# DEVELOPMENT REVIEW COMMITTEE (DRC) COMMENT REPORT

**PROJECT NAME:** RD Las Olas Residences

**CASE NUMBER:** UDP-S22041

**REQUEST:** Site Plan Level II Review: 192 Multifamily Residential Units and 3,684 Square-Feet of Restaurant Use in the Downtown Regional Activity Center

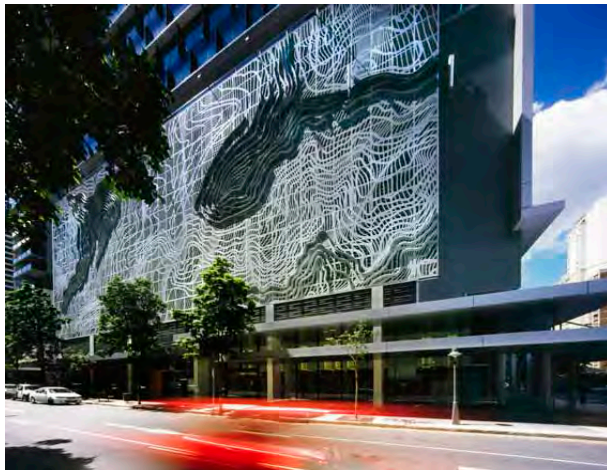
9. In regard to physical, communication, and radar obstructions, the FAA requires a review for interference by the proposed construction of buildings. Provide a letter from the FAA indicating that such review has been performed based on proposed building height. FAA approval must be obtained prior to Final-DRC sign-off unless otherwise deemed unnecessary by the FAA.
10. The project does not meet certain Downtown Master Plan (DMP) design intents as outlined in ULDR, Section 47-13.20 and Section 47-13.21, respectively. Staff has commented below under the applicable category and has provided images to assist the applicant.

### Quality of Architecture

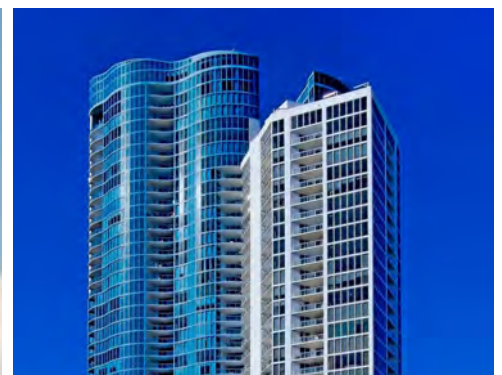
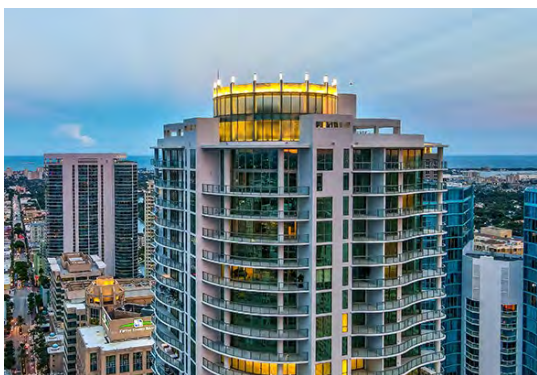
- j. Q1, Skyline Drama; the proposed tower top does not meet the intent outlined in the DMP which states that buildings in special prominence in key locations should have sculptural elements designed to be seen from various angles. This building will be the first tower seen from Las Olas Boulevard facing west. At preliminary meeting, staff indicated the need to address the visibility of the tower and east façade from Las Olas, which was not addressed. Revise the design to meet the design intent. Images have been provided below.

- k. Q2, Expressive Tops; staff recommends exploring other tower top shapes such as angled, vertically expressive, or other design that results in a stronger, more dramatic design.
